Pin-Compatibility Between ADC08D1000/1500 and ADC08D1020/1520

Dawn Ostenberg
National Semiconductor
DCS Applications, Santa Clara
Apr 6, 2007

**This note addresses the question:
*“if a board is designed for ADC08D1000 or the ADC08D1500, what, if any,
changes must be made in order to upgrade to the newer ADC08D1020/1520
devices?”***

Pinout Comparison: ADC08D1000/1500 versus ADC08D1020/1520

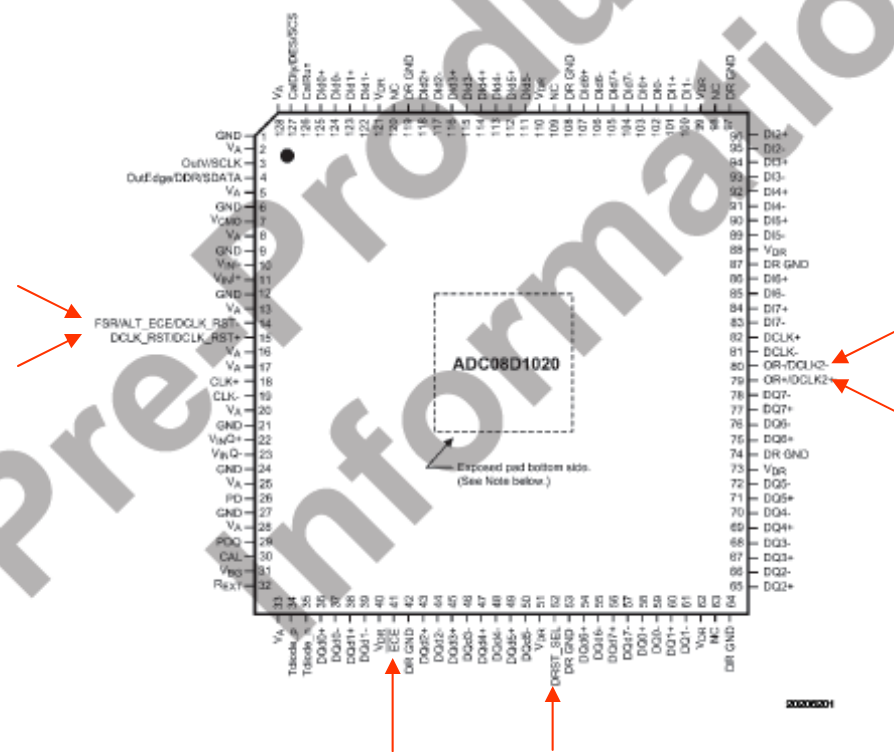
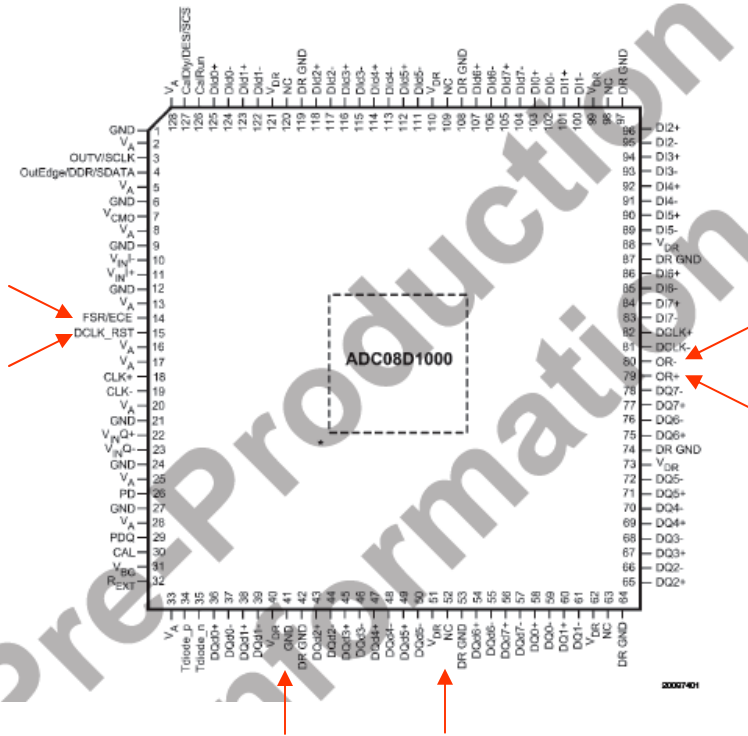
The pins that are affected are pin #s: 14, 15, 41, 52, 79, and 80.

Pin #	Pin Name		Pin Function	
	ADC08D1000/1500	ADC08D1020/1520	ADC08D1000/1500	ADC08D1020/1520
14	FSR/ECE	FSR/ALT_ECE/DCLK_RST-	Pin can be tied to VA or AGND to set the FSR of the ADC. When floating, ADC is in the Extended Control Mode.	Pin has similar function as previous generation device when pin 52 is floating or high. It has the added functionality of DCLK_RST- (negative polarity of differential input) when pin 52 is grounded.
15	DCLK_RST	DCLK_RST/DCLK_RST+	A positive singled-ended CMOS pulse on this pin resets the DCLK.	Pin has similar function as previous generation device when pin 52 is floating or high. It has the added functionality of DCLK_RST+ (positive polarity signal of differential input) when pin 52 is grounded.
41	GND	ECE-	Tied to GND	This pin is now the primary way for putting the device into Extended Control Mode. Tie pin to ground to activate Extended Control Mode.
52	NC	DRST_SEL	No Connect	Pin used to select between a single-ended DCLK_RST (when high) or differential DCLK_RST input (when low).

79	OR+	OR+/DCLK2+	This pin becomes active when an out-of-range input signal level is detected.	Pin has same functionality as previous generation device by default. With a control register bit setting it can be configured as a second DCLK output.
80	OR-	OR-/DCLK2-	This pin becomes active when an out-of-range input signal level is detected.	Pin has same functionality as previous generation device by default. With a control register bit setting it can be configured as a second DCLK output.

- Every attempt was made to maintain a high level of backward compatibility.
- If you want to use the two new features that affect the pinout: the second DCLK in place of the OR or the differential DCLK_RST, then, of course, the connections to those pins will have to be modified.
- If the differential DCLK_RST and second DCLK are irrelevant to your design, then there is only one pin's connection that may need to be modified.
 - If the current board design is grounding pin 41, then the ADC08D1020/1520 will enter the extended control mode upon power-up. If your design uses extended control mode at all times, then no board modification is necessary.
 - If your design uses pin-control instead of extended control, or if you power-up with pin-control and then switch to extended control, then pin 41 connection would have to be modified – i.e., either tie it high, or drive its logic state high.
